Access Compliance Report

Public Rights-of-Way

(Curb Ramps)

Intersection ID: 9082	Main Street: BARRINGTON_DR	Cross Street: SOMERSWORTH_DR	Location: W
ADA ID: F52776B4FCD9	Ramp Type: Perp	Initial Pass/Fail: Fail	Overall Compliance: No
		Severity Score: 25

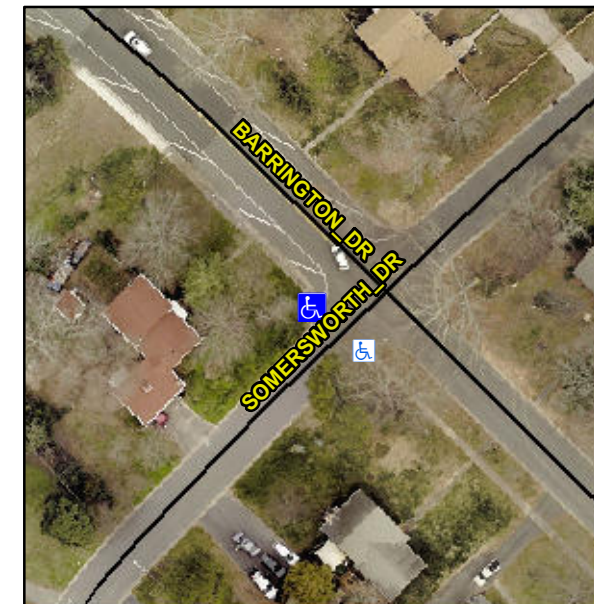
Not Found, R304.2.2, R304.5.3

Compliance	Description	Data	Compliance	Description	Data
N/A	Ramp Length (in)	61.0	No	Ramp Slope (%)	9.2
Yes	Ramp Width (in)	48.0	No	Ramp XSlope (%)	6.6
N/A	Flare Type LT	N/A	N/A	Flare Type RT	N/A
N/A	Flare Slope LT (%)	N/A	N/A	Flare Slope RT (%)	N/A
N/A	Flare Traversable LT?	N/A	N/A	Flare Traversable RT?	N/A
N/A	Landing Length (in)	N/A	N/A	DWS Provided?	N/A
N/A	Landing Width (in)	N/A	N/A	DWS Contrast?	N/A
N/A	Landing Slope (%)	N/A	N/A	DWS Length (in)	N/A
N/A	Landing X Slope (%)	N/A	N/A	DWS Full Width?	N/A
N/A	Landing Curb? (Y/N)	N/A	N/A	DWS Offset (in)	N/A
N/A	Shared Landing?	N/A			
N/A	Gutter Ponding?	N/A	N/A	Gutter Slope (%)	N/A
N/A	Gutter Lip Ht (in)	1.0	N/A	Gutter X Slope (%)	N/A
N/A	Painted X Walk1?	No	N/A	Painted X Walk2?	N/A
	X Walk 1 Direction	To SE		X Walk 2 Direction	N/A
N/A	X Walk 1 Width (in)	N/A	N/A	X Walk 2 Width (in)	N/A
	X Walk 1 Slope (%)	6.2		X Walk 2 Slope (%)	N/A
	X Walk 1 X Slope (%)	4.6		X Walk 2 X Slope (%)	N/A

Remove & Replace Entire Ramp.
